To: Kristopher Byrd, Well Construction and Compliance Section Manager
From: Travis Kelly, Well Construction Program Coordinator
Subject: Re-Review of Water Right Application G-18915
Date: July 13, 2020

Application # G- 18915

SUBJECT: Scenic Waterway Interference & General/Local Surface Water Evaluation for Deschutes Ground Water Study Area

TO: Water Rights Section Date 6/17/2020
 FROM: Groundwater Section Aurora C Bouchier
Reviewer's Name
 SUBJECT: Application G- 18915 Supersedes review of na
Date of Review(s)

Water-Level Trends in Nearby Wells

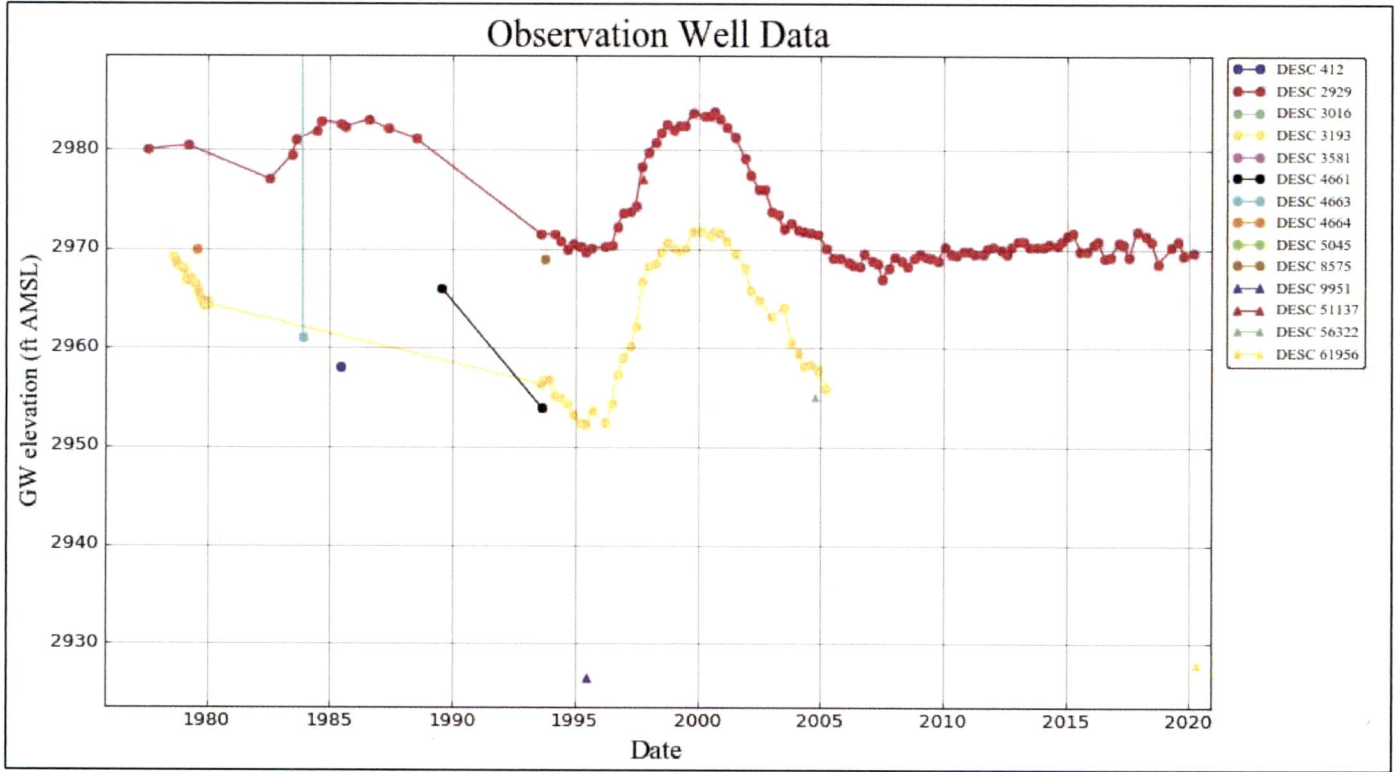
The well is located within the Sisters Fault Zone. As such, relevant observation wells are similarly located within the fault zone. There are 2 relevant observation wells: DESC 3193 (located approximately 9.2 miles to the northwest which was monitored periodically from the late 1970's through 2005) and DESC 2929 (located approximately 13.6 miles to the northwest which has been monitored from the late 1970's through present). The hydrographs for DESC 3193 and DESC 2929 show a strong response to climate cycles through approximately 2006, after which point DESC 2929 appears to show a muted response to climate cycles.

For comparison sake, wells located up-gradient of the fault zones (such as DESC 3016 located in Sisters) continue to show a strong response to climate cycles through present. However, wells located down-gradient of the fault zones (DESC 3581 located in Redmond and DESC 5045 located in Bend) show a persistent decline since the mid 1990's through present.

It appears that the fault zone acts to retard the propagation of the groundwater decline. It is likely that addition groundwater production within the USGS Deschutes Ground Water Study Area (DGWSA) will act to further exacerbate the groundwater declines seen down-gradient of the fault zones (Sisters and Brothers fault zones). However, the cumulative 200 cfs cap on groundwater permits has not yet been reached (Division 690-505-0500).
